**APPENDIX A AMENDMENT**  
**T198 LINE – STRUCTURE 29-30**  
**SOUTH BRANCH OF ASHUELOT RIVER AND STATE ACQUIRED**  
**RAILROAD PROPERTY**  
**TROY, NH**

1. The design and proposed construction of this crossing is shown on the attached PSNH Transmission Drawing entitled “LINE T198 (115 KV) CROSSING BETWEEN STR. 29 & 30, SOUTH BRANCH ASHUELOT RIVER, TROY, NEW HAMPSHIRE”.

THIS DRAWING REPLACES THE PREVIOUS DRAWING DATED 7/2008 AND CONTAINS UPDATED CABLE SAGS & CLEARANCES.

TRANSMISSION BUSINESS
	<b>LINE T198 (115kV) CROSSING BETWEEN STR. 110 &amp; 111 SOUTH BRANCH ASHUELOT RIVER CROSSING SWANZEY, NEW HAMPSHIRE</b>
DRAWN: RRR ENGINEER: AM CHECKED: RPL APPROVED: DMB	SCALE: AS SHOWN DATE: 8/13 DRAWING NO.: EXHIBIT G2 AMENDMENT

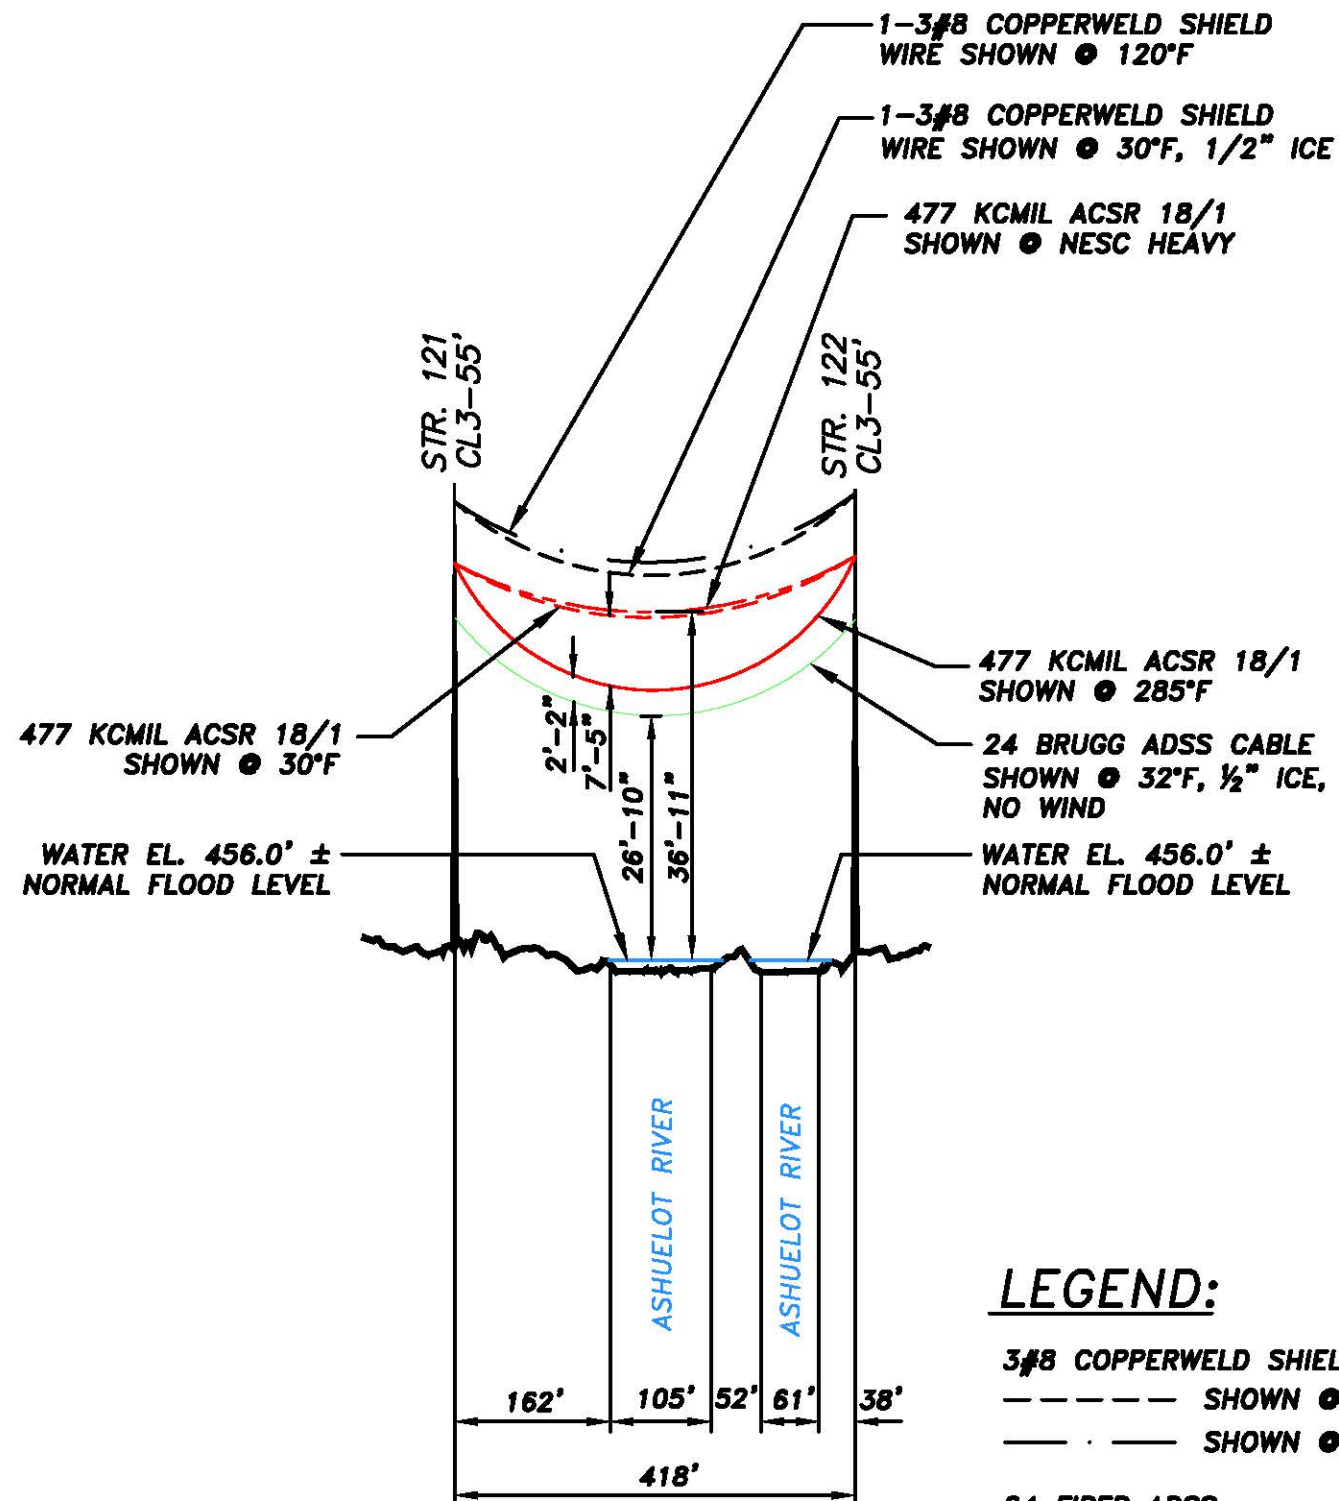
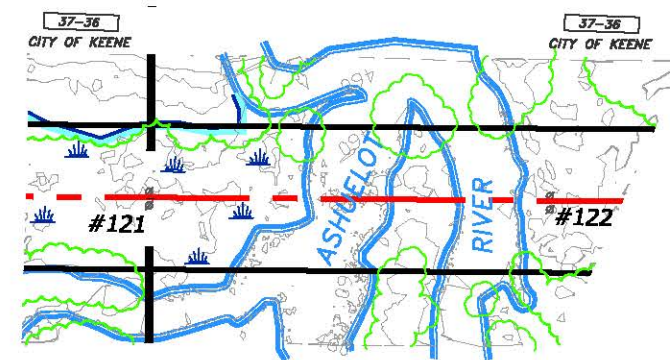
2. Currently, Line T198 crosses the Ashuelot River on a 55’ type A structure (West) and a 60’ type C structure (East) with a span of 427.71 feet. Detailed drawings of these structures have been provided with this amendment. Minimum distances to ground for pedestrian access of 9.5 feet for the ADSS and 16.1 feet for the 115kV open supply per the NESC have been met as 18.6 and 19.6 feet of clearance is provided respectively for the ADSS and conductor wires.

6. As stated in the NESC (Table 232-1, Note 18), the surface area shall be enclosed by its high water mark and clearances shall be based on the normal flood level. In this case, the final river elevation at this location during the normal flood is 456.4 feet. The current sags and clearances to the water surface are as follows:

- Conductors (phase wires) – The maximum sag for the conductor will occur under the maximum operating condition (285 deg F). This condition produces the greatest sag and therefore the minimum clearance to water surface. At the time of the original petition, the clearance to water surface exceeded the minimum requirement of 22.1 feet with a clearance of 24.4 feet under temporary emergency conditions. The clearance to the water surface of the conductor, under the maximum operating condition, after thermal uprate will be 25.6 feet.

- ADSS cable – The maximum sag for the ADSS cable will occur under the weather case of 32 deg F; ½ inch radial ice; no wind and therefore produces the minimum clearance to the water surface. At the time of the original petition, the clearance to water surface exceeded the minimum requirement of 17.5 feet with a clearance of 23.9 feet.

THIS DRAWING REPLACES THE PREVIOUS DRAWING DATED 7/2008 AND CONTAINS UPDATED CABLE SAGS & CLEARANCES.

<b>Public Service of New Hampshire</b>	<b>TRANSMISSION BUSINESS</b>
	<b>LINE T198 (115kV) CROSSING BETWEEN STR. 130 &amp; 131</b> <b>ASHUELOT RIVER CROSSING SWANZEY, NEW HAMPSHIRE</b>	
DRAWN RRR ENGINEER AM CHECKED RPL APPROVED DMB	SCALE AS SHOWN	DATE 8/13
DRAWING NO. EXHIBIT J2 AMENDMENT

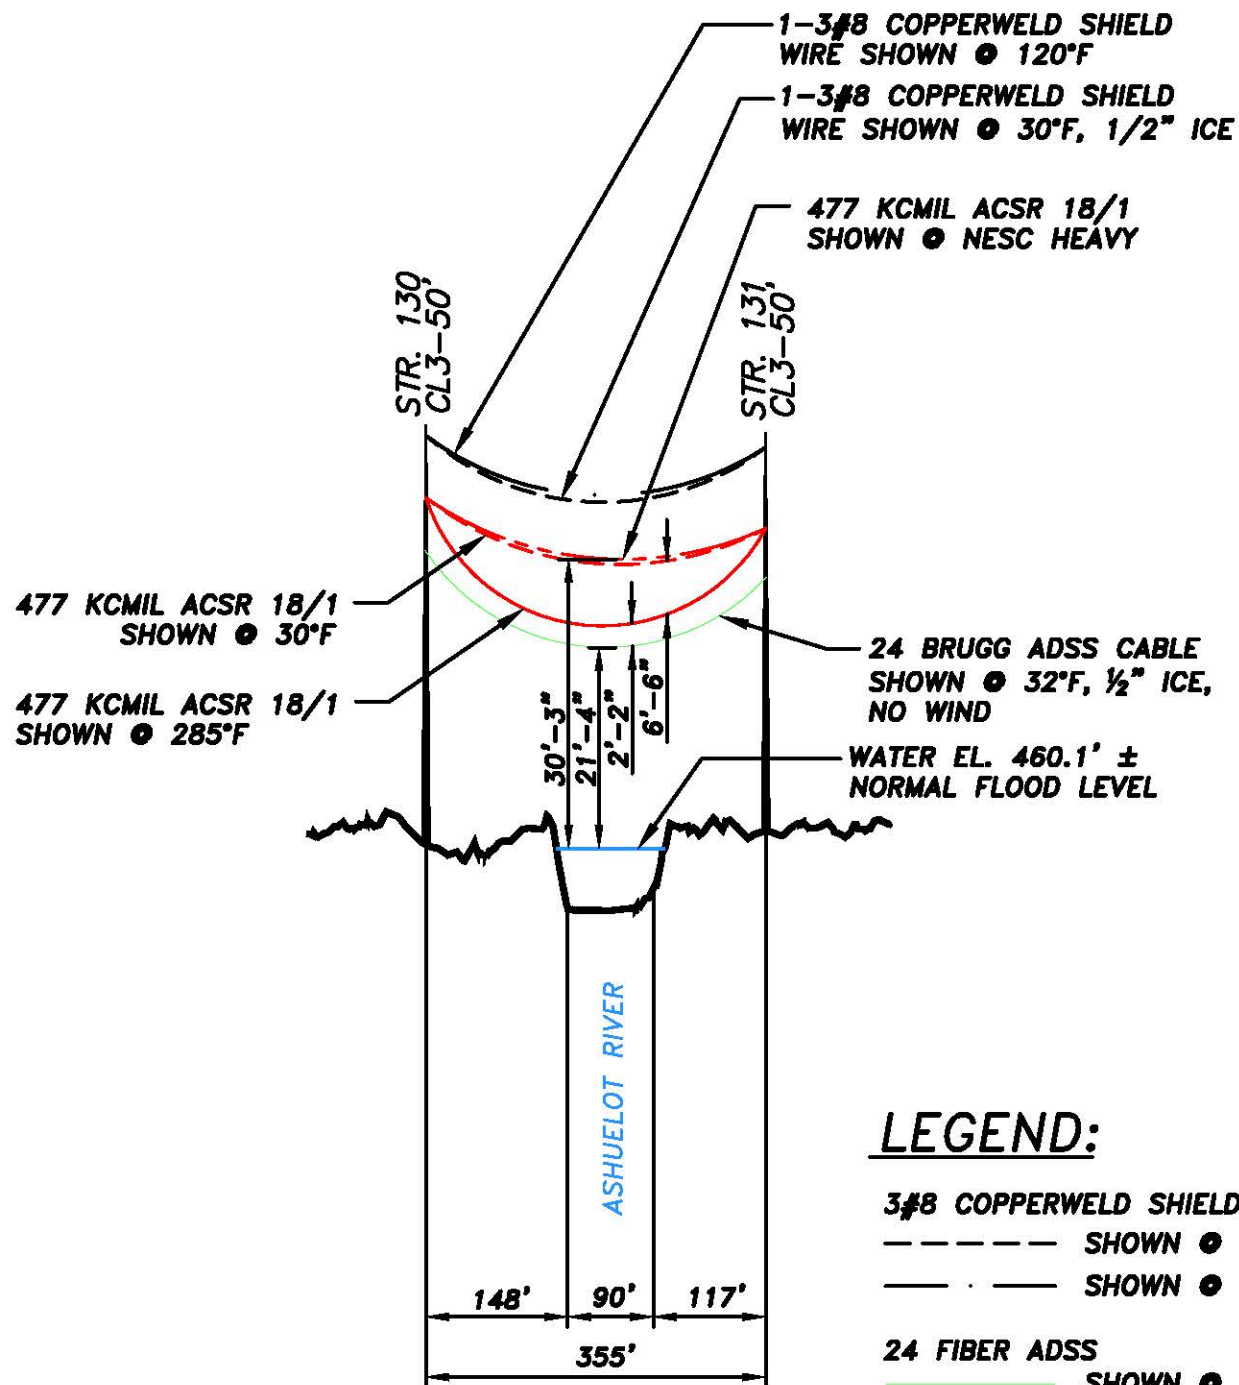
2. Currently, Line T198 crosses the South Branch Ashuelot River on an 50’ type C structure (West) and a 50’ type A structure (East) with a span of 354.54 feet. Detailed drawings of these structures have been provided with his amendment. Minimum distances to ground for truck traffic of 9.5 feet for the ADSS and 16.1 feet for the 115kV open supply per the NESC have been met as 17.1 and 19.1 feet of clearance is provided respectively for the ADSS and conductor wires.

THIS DRAWING REPLACES THE PREVIOUS DRAWING DATED 7/2008 AND CONTAINS UPDATED CABLE SAGS & CLEARANCES.

TRANSMISSION BUSINESS
	<b>LINE T198 (115kV) CROSSING BETWEEN STR. 151 &amp; 152</b> <b>ASHUELOT RIVER CROSSING KEENE, NEW HAMPSHIRE</b>
DRAWN: RRR ENGINEER: AM CHECKED: RPL APPROVED: DMB	SCALE: AS SHOWN DATE: 6/13 DRAWING NO.: EXHIBIT K2 AMENDMENT

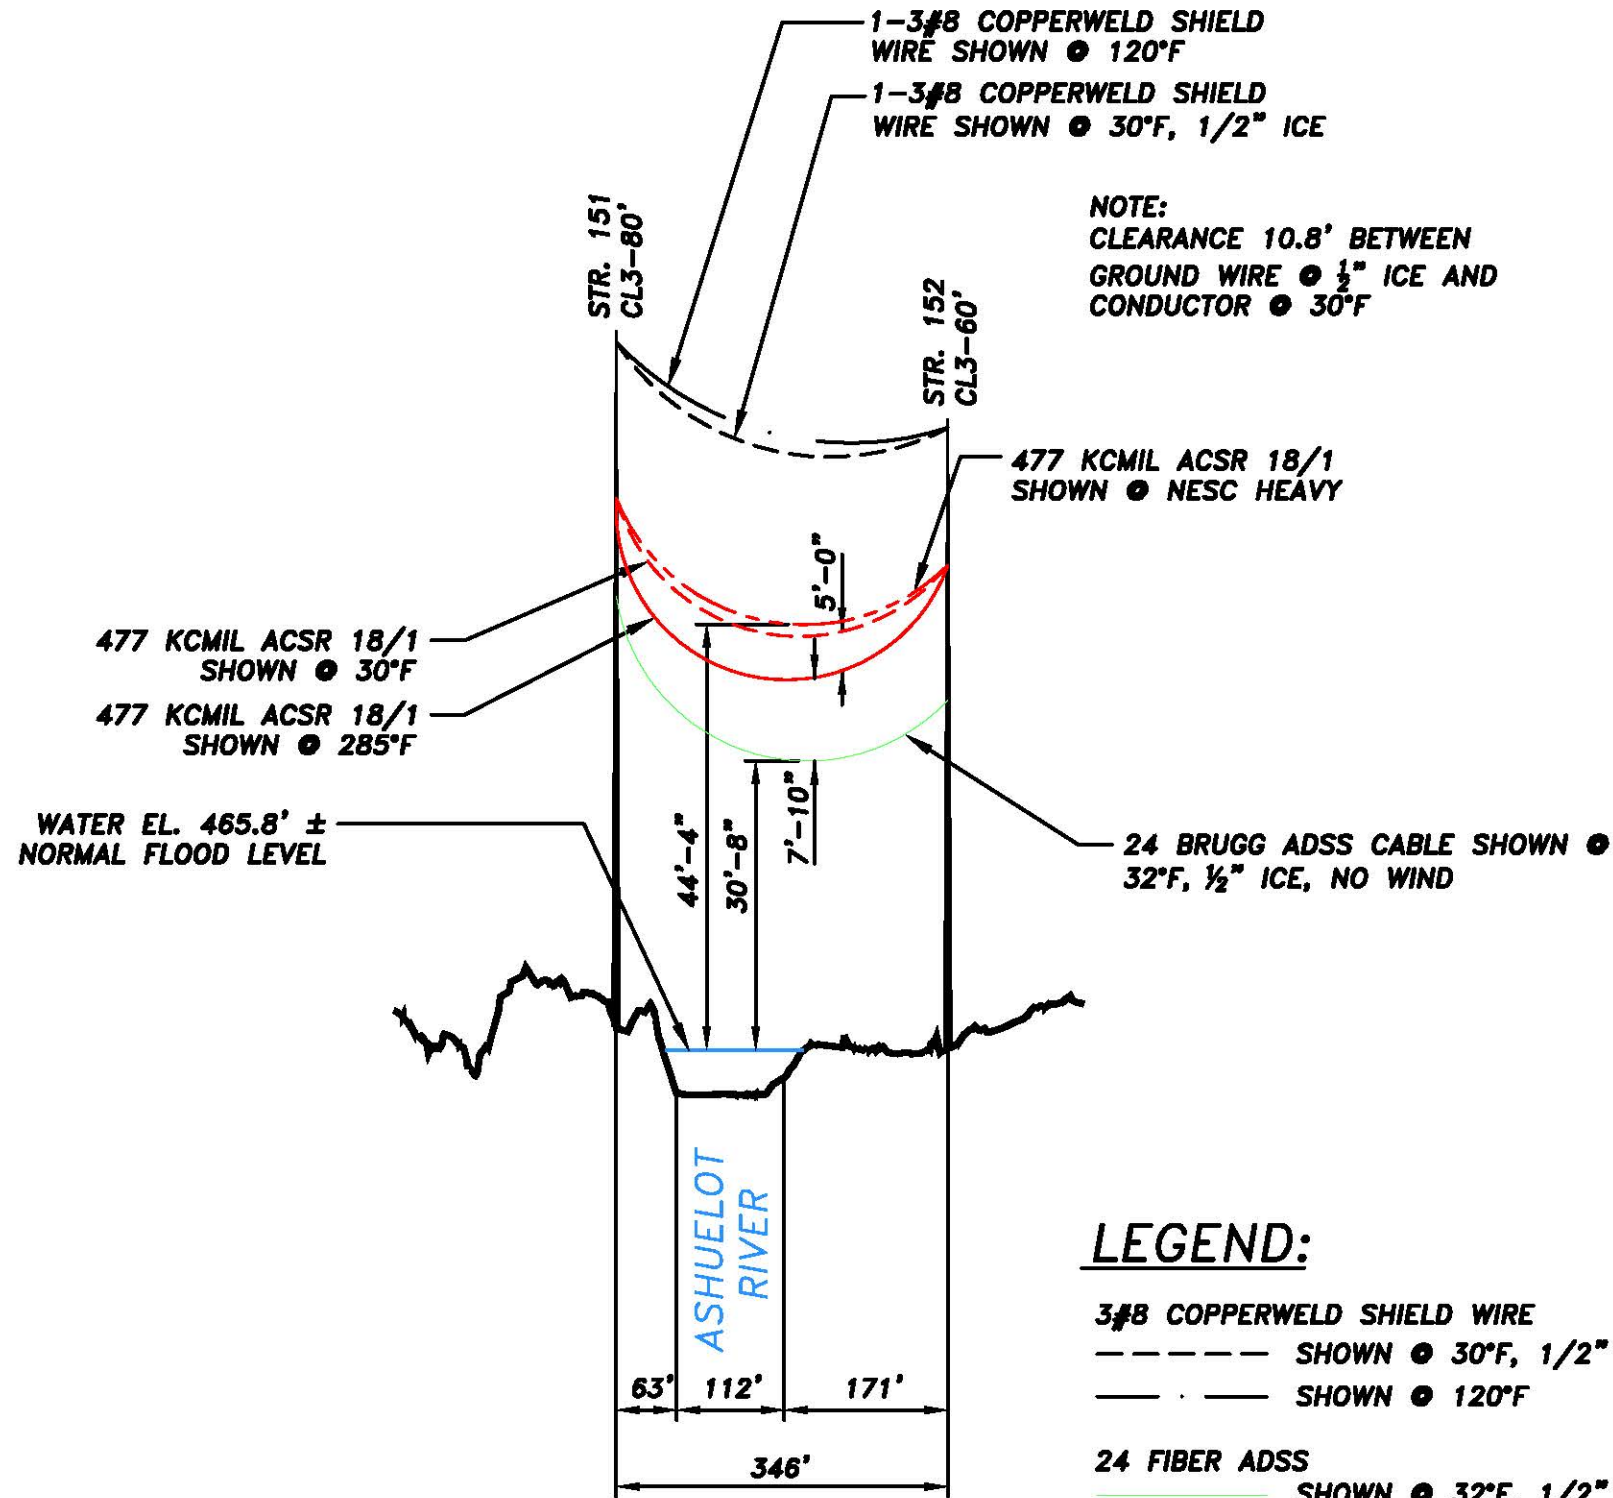
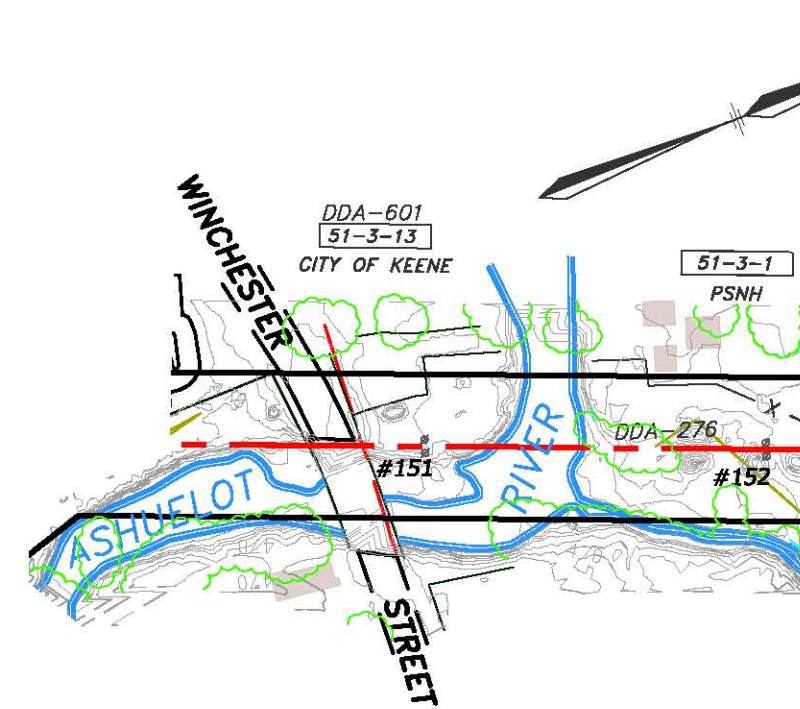
3. After replacement, Line T198 will cross the Ashuelot River on an 80’ type RAX structure (West) and a 60’ Type A3 structure (East) with a span of 346 feet. A detailed drawing of the new structure has been provided with this amendment.

7. Currently, Line T198 crosses the Ashuelot River on a 70’ type D3 structure (West) and a 60’ type A3 structure (East) with a span of 355.38 feet. Detailed drawings of these structures have been provided with his amendment. Minimum distances to ground for truck traffic of 15.5 feet for the ADSS and 20.1 feet for the 115kV open supply per the NESC have been met as 23.5 and 25.5 feet of clearance is provided respectively for the ADSS and conductor wires.
8. After replacement, Line T198 will cross the Ashuelot River on an 80’ type RAX structure (West) and a 60’ Type A3 structure (East) with a span of 346 feet. A detailed drawing of the new structure has been provided with this amendment.

NOTE:  
CLEARANCE 10.8' BETWEEN  
GROUND WIRE @ 1/2" ICE AND  
CONDUCTOR @ 30°F

THIS DRAWING REPLACES THE PREVIOUS DRAWING DATED 7/2008 AND CONTAINS UPDATED CABLE SAGS & CLEARANCES.
